**DOCUMENT 00 90 00
ADDENDUM**

ADDENDUM NO. [1] Date: November 25, 2019

**RE: SOUTHWEST WISCONSIN TECHNICAL COLLEGE
 BOOKSTORE REMODEL
 1800 BRONSON BLVD
 FENNIMORE, WI
 BID NUMBER: 1920-05**

**FROM: HSR Associates, Inc
 100 Milwaukee Street
 La Crosse, WI 54603
 (608) 784-1830**

A090

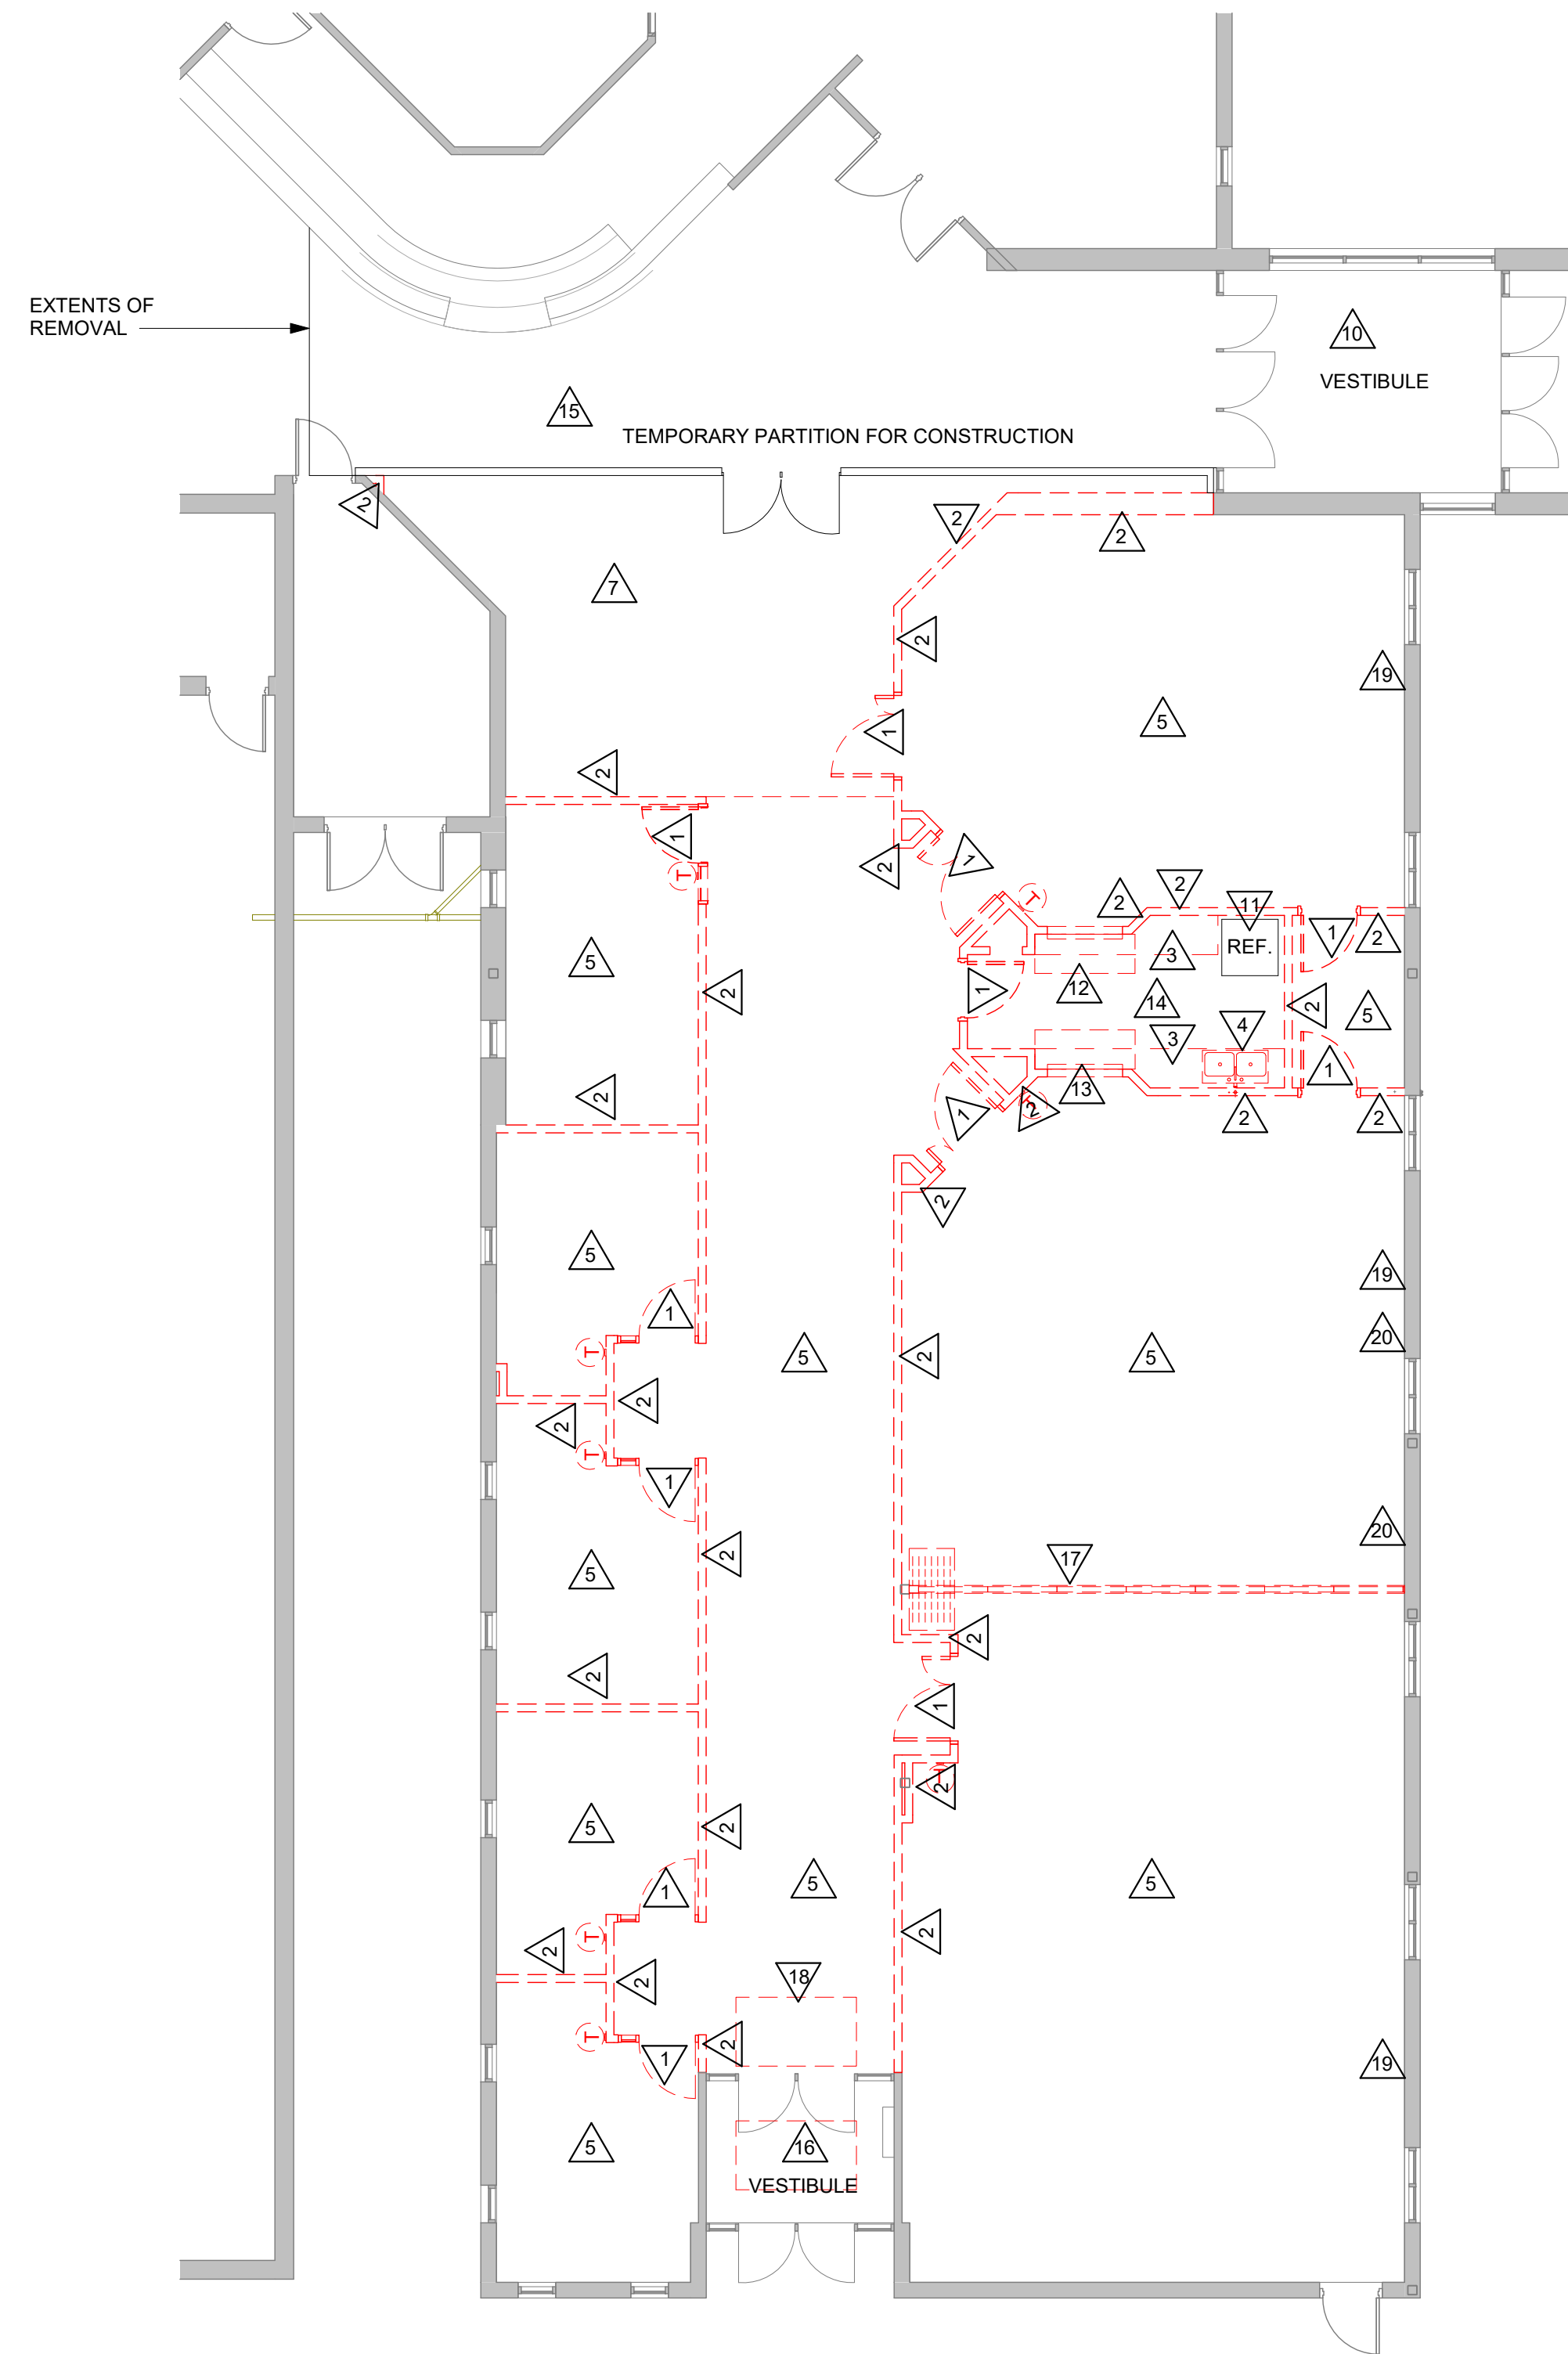
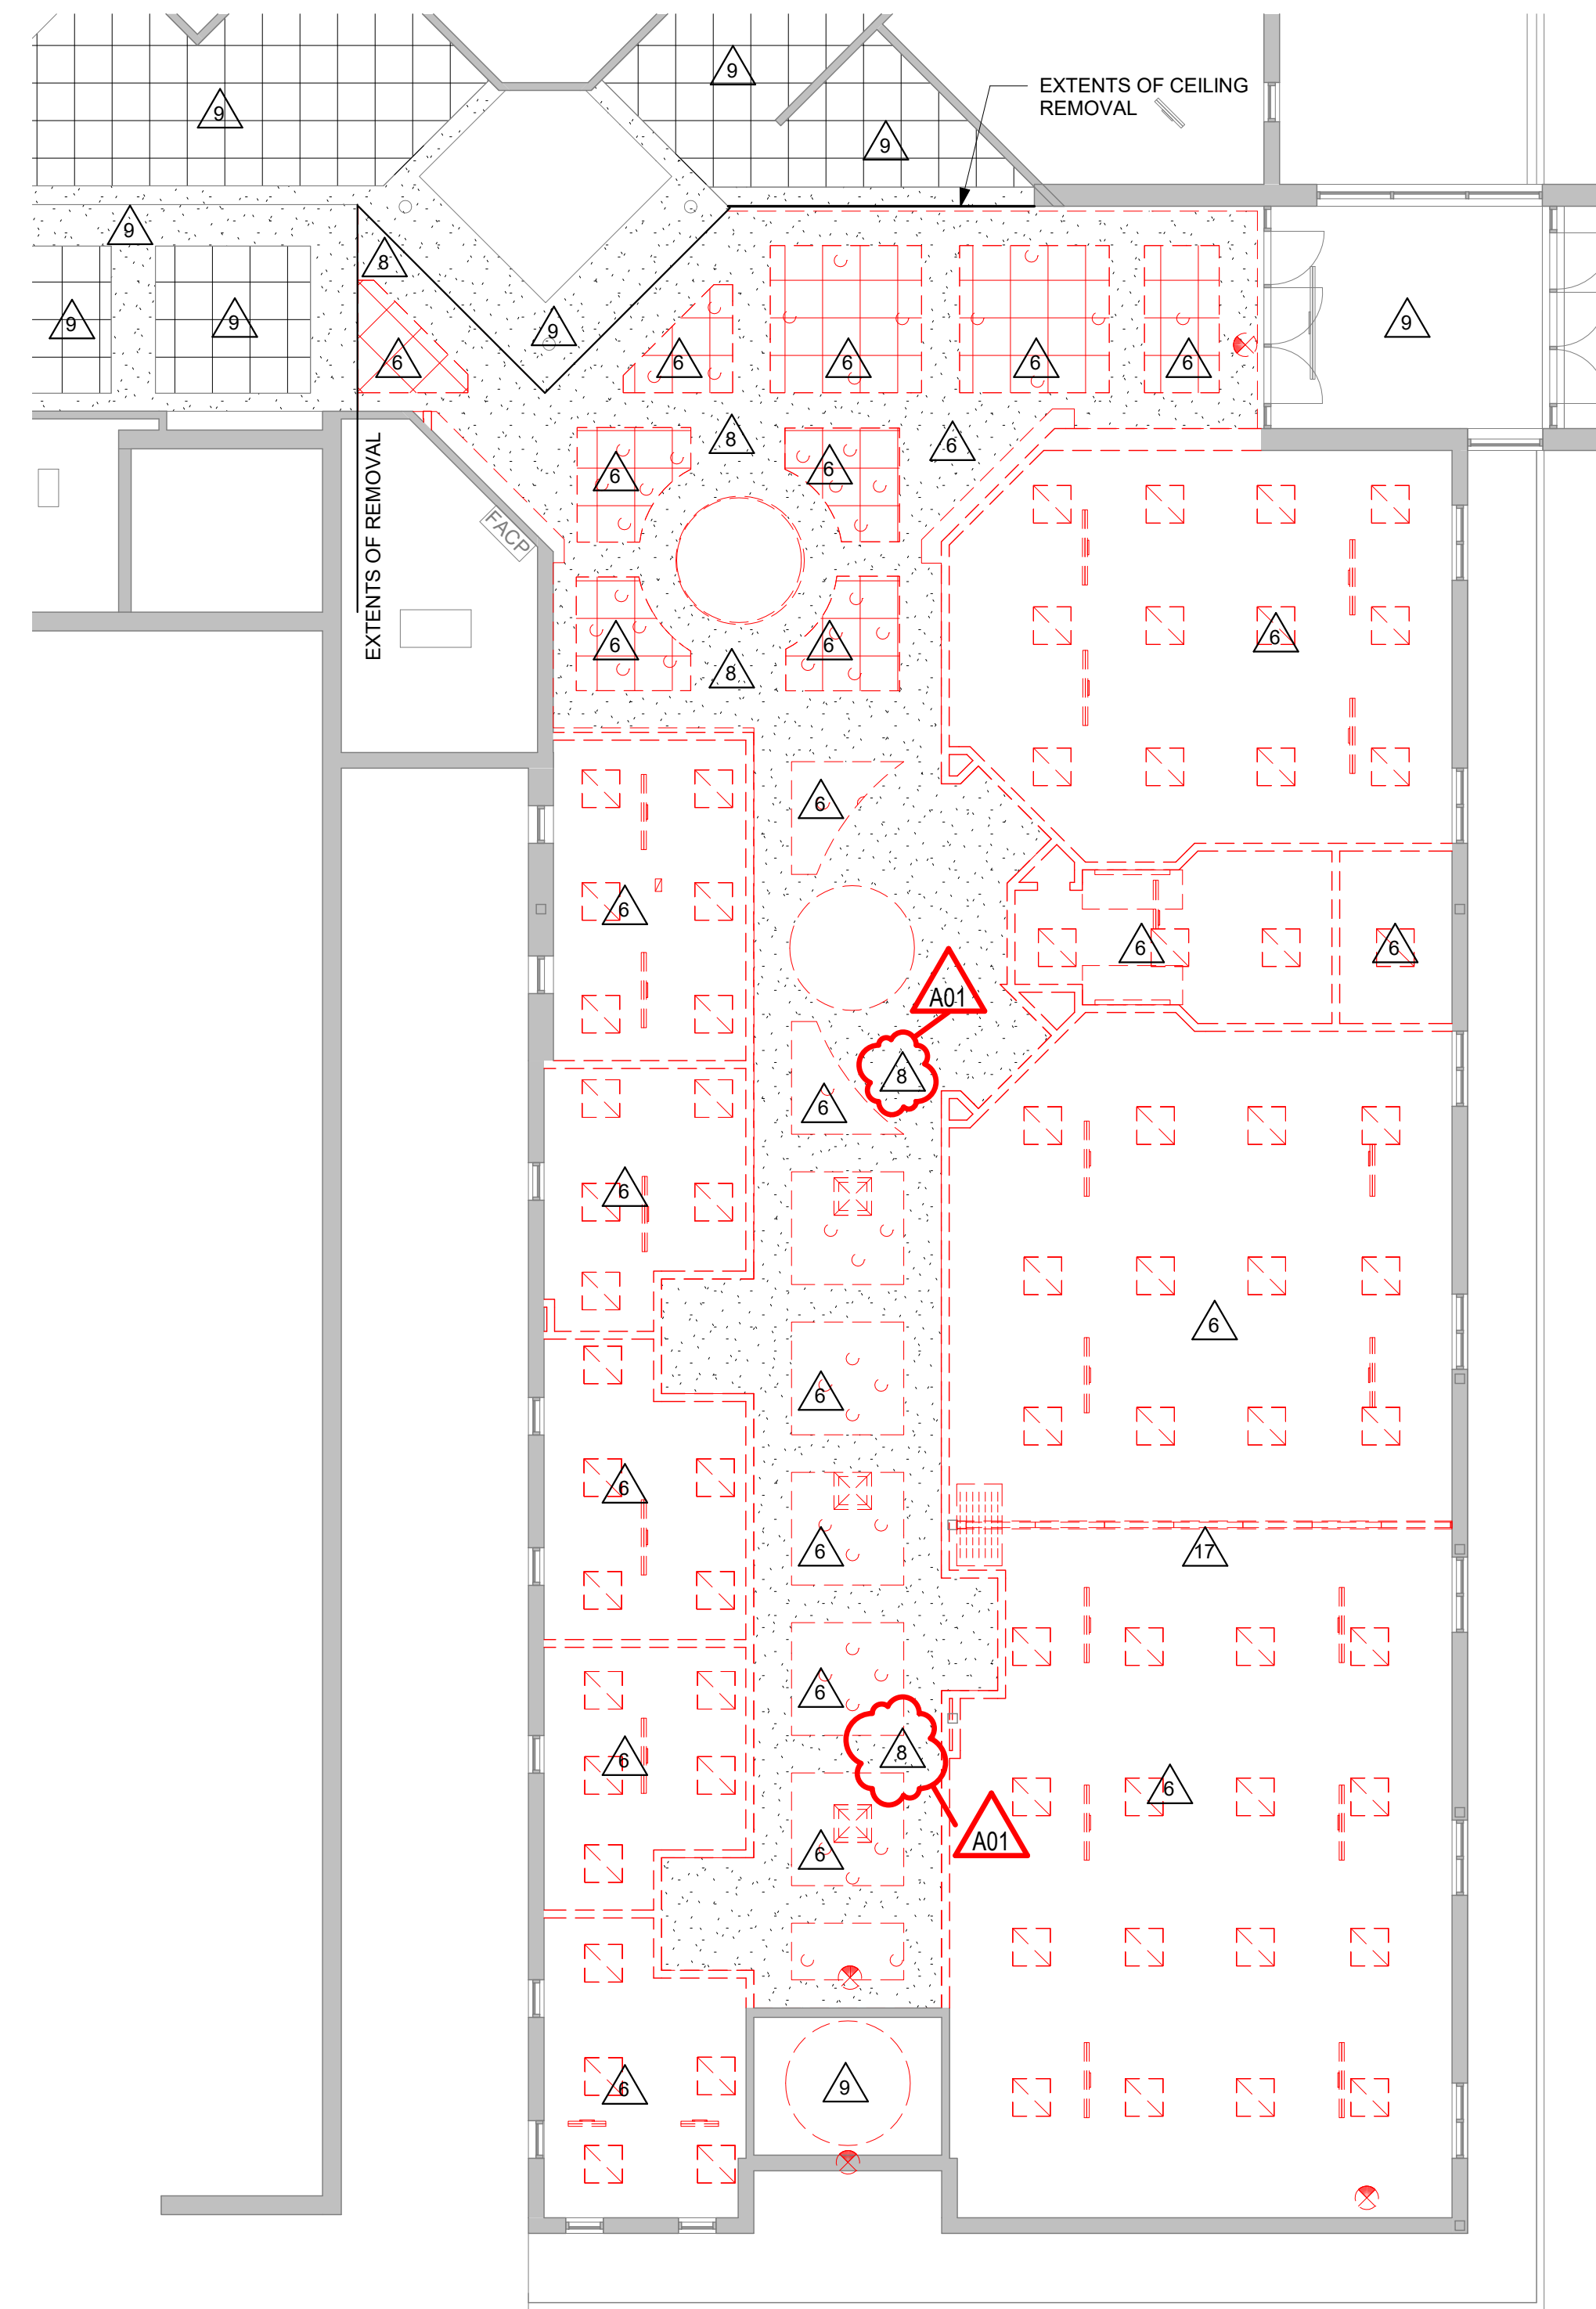
3. Sheet A090 DEMO PLANS 30 x 42 attached hereto
 - a. Revisions clouded on Drawings
4. Sheet A100 REMODEL PLAN AND REFLECTED CEILING PLAN 30 x 42 attached hereto
 - a. Revisions clouded on Drawings
5. Sheet E090 DEMOLITION PLAN 30 x 42 attached hereto
 - a. Revisions clouded on Drawings
 - b. Add note for vestibule handicap access.
 - c. Added junction boxes for power openers.
 - d. Added note for vestibule lighting.
 - e. Added General Note "G".
6. Sheet E200 POWER PLAN 30 x 42 attached hereto
 - a. Revisions clouded on Drawings
 - b. New sound system speakers added (a) and intercom speakers (b) all designated.
 - c. Vestibule card reader new install.
 - d. Add notes for existing Handicap access.
 - e. Added existing junction boxes for handicap power openers
 - f. Modified General Note "H".
